VPN-004-2019

**Submittal of Response to NRC's Request for Additional Information  
Related to the Trojan ISFSI License Change Application (LCA 72-07) for  
License Renewal (CAC No. 001028)**

**RESPONSE TO NUCLEAR REGULATORY COMMISSION (NRC)  
REQUEST FOR ADDITIONAL INFORMATION FOR THE  
TECHNICAL REVIEW OF THE APPLICATION FOR RENEWAL OF THE  
TROJAN INDEPENDENT SPENT FUEL STORAGE INSTALLATION  
LICENSE NO. SNM-2509**

**FIGURE 3-1**  
**TROJAN ISFSI PROJECT TIMELINE**

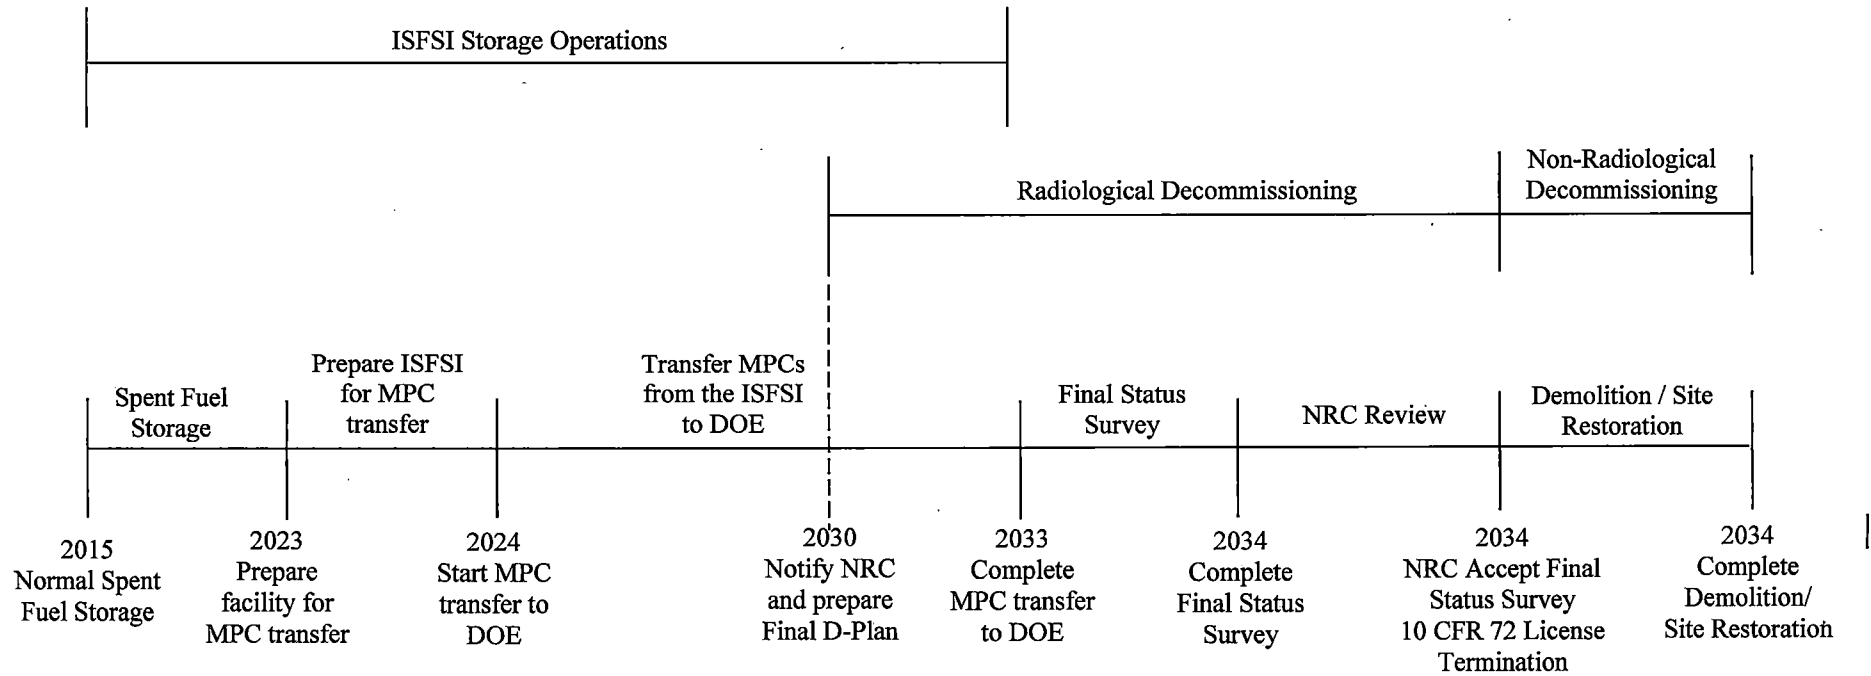
Provide the current estimated operating and maintenance costs for the Trojan ISFSI, as well as sources of funds, over the planned life of the ISFSI. Additionally, provide the rationale for these cost projections.

The planned life of the Trojan ISFSI is currently projected to end in year 2034. This is described in Section 3.1 (PGE's Assumptions and Basis for the Trojan ISFSI Projected Radiological Decommissioning Schedule) of PGE-1082, "Trojan ISFSI Preliminary Radiological Decommissioning Plan," which is included in Appendix H of the Trojan LRA. This section refers to Figure 3-1 (Trojan ISFSI Project Timeline) in PGE-1082, which is attached and shows the current overall project timeline of major activities including ISFSI radiological decommissioning and projected dates. PGE plans to add at least ten years to the projected dates for major activities in the Trojan ISFSI Project Timeline in Figure 3-1 in the next revision to PGE-1082, due to be submitted to NRC in 2020.
